LINOTYPE IMPROVEMENT SHEET

NO. 322

BALL BEARING ROLL (HYDRAQUADDER)

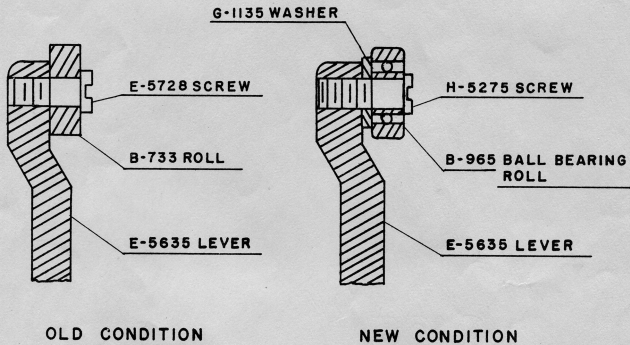
A Ball Bearing Roll B-965 has been adopted to replace the solid operating Cam Roll B-733, to insure the roll turning under all conditions.

Can be applied to all Outstanding Models equipped with Hydraquadder by using B-965 Roll, H-5275 Screw and G-1135 Washer.
